## HISTORIC AND DESIGN REVIEW COMMISSION

September 06, 2017

**HDRC CASE NO:** 2017-425  
**ADDRESS:** 1108 S FLORES ST  
**LEGAL DESCRIPTION:** NCB 2556 BLK A LOTS 3 TO 7  
**ZONING:** C-3NA, H  
**CITY COUNCIL DIST.:** 1  
**DISTRICT:** Nathan Historic District  
**APPLICANT:** Scott Glenn  
**OWNER:** Jeremy Jessop/Tobin Equity Real Estate, LLC  
**TYPE OF WORK:** Exterior modifications, roof top addition, fenestration modifications and signage  
**REQUEST:**

② **Daniel Street Elevation Scheme One**  
1/16" = 1'-0"

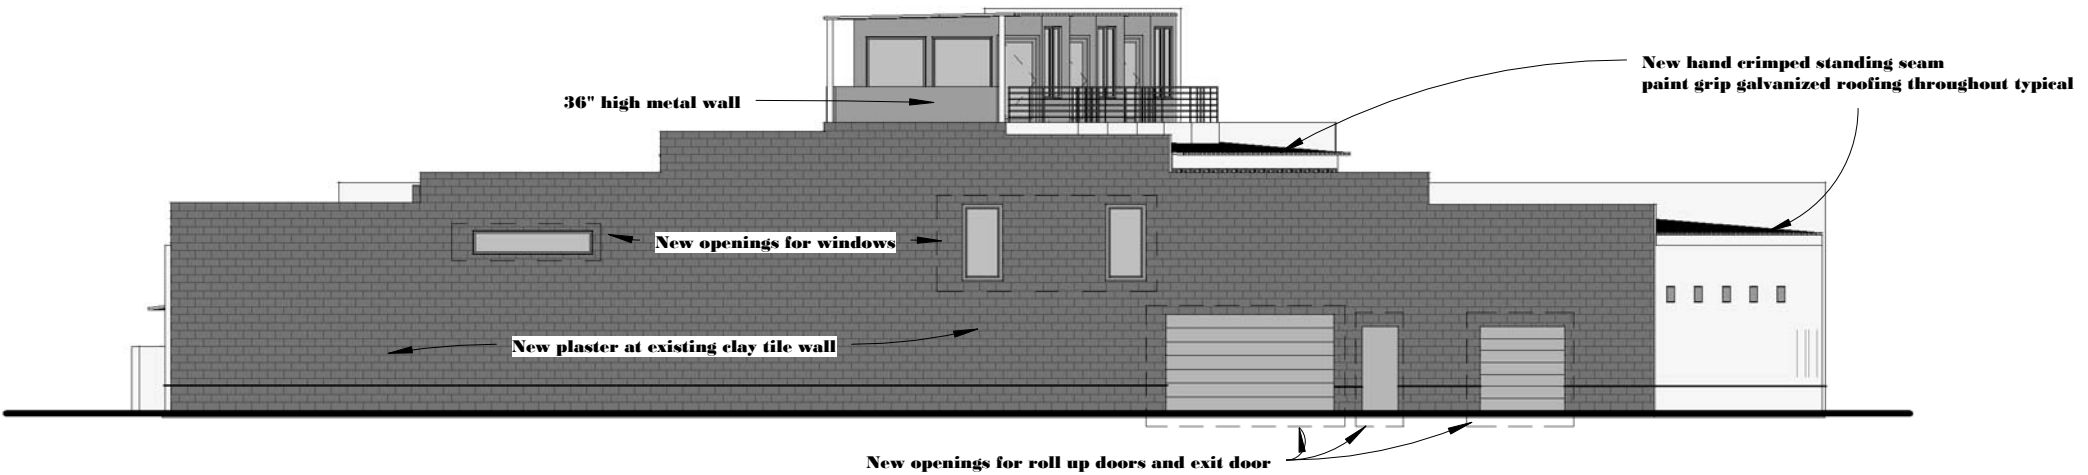
- f. EXTERIOR MODIFICATIONS (Daniel) – On the Daniel elevation, the applicant has proposed to remove six existing window openings, one pedestrian door and its associated side lights and an overhead rolling door and install three pedestrian entrances and overhead canopies. Staff finds the proposed modifications to be appropriate and consistent with the overall architectural character of the building. Additionally, the proposed entrance canopies are simple in nature, consistent with the architecture of the existing structure.

- i. That proposed window openings should feature windows with a profile consistent with those of this structure. The windows should feature an inset of at least two inches and should feature aluminum or metal frames that are colored in a dark color.
- ii. That the applicant provide staff with a color selections for all stucco, plaster and façade material colors.
- iii. That the proposed signage feature indirect or back lighting and that vinyl or plastic sign faces are not used.

1 Alley Elevation Scheme One  
1/16" = 1'-0"

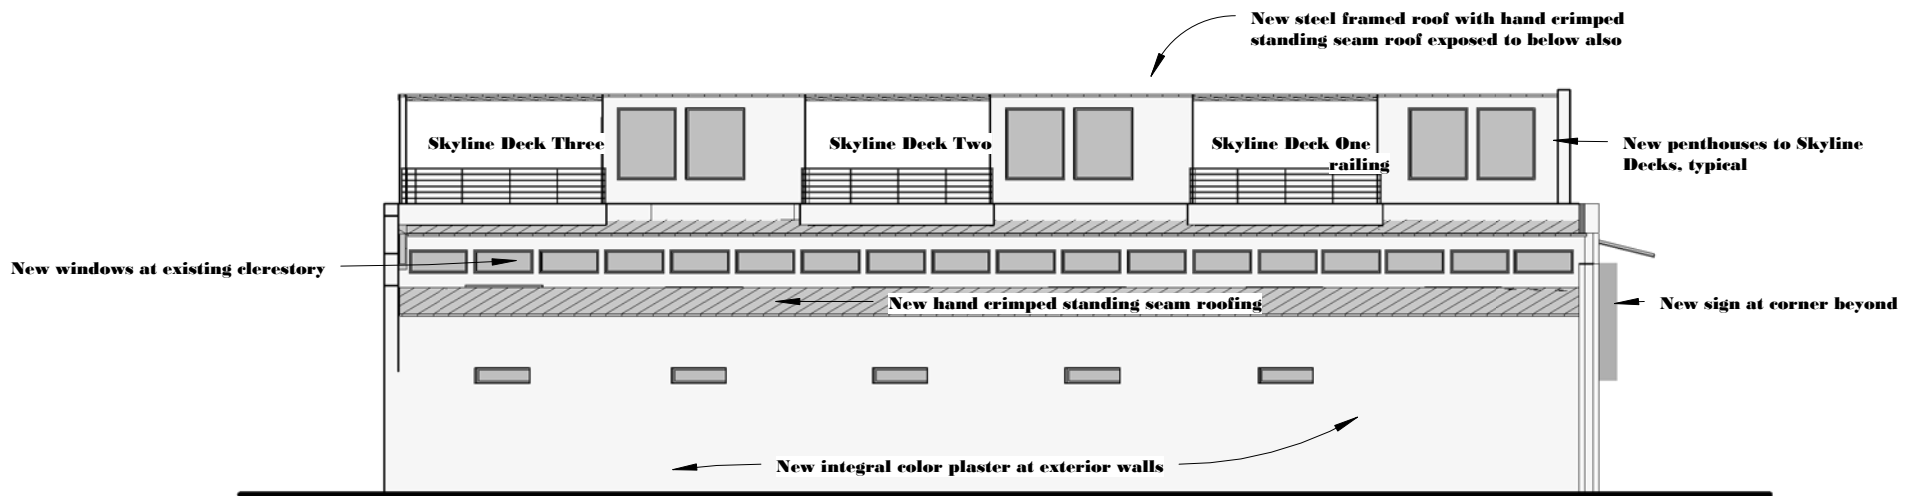
- e. EXTERIOR MODIFICATIONS (Alley) – On the alley façade, the applicant has proposed the modifications that include the removal of one pedestrian door opening and the installation of two overhead rolling doors, a new pedestrian door opening and three windows. Given the location of this façade at an alley and not visible from S Flores, staff finds these modifications appropriate. The proposed window openings should feature windows with a profile consistent with those of industrial structures of this era. The proposed rolling doors should feature high quality materials to match the proposed steel door on the S Flores façade. The proposed windows should feature an inset of at least two inches within the existing walls.
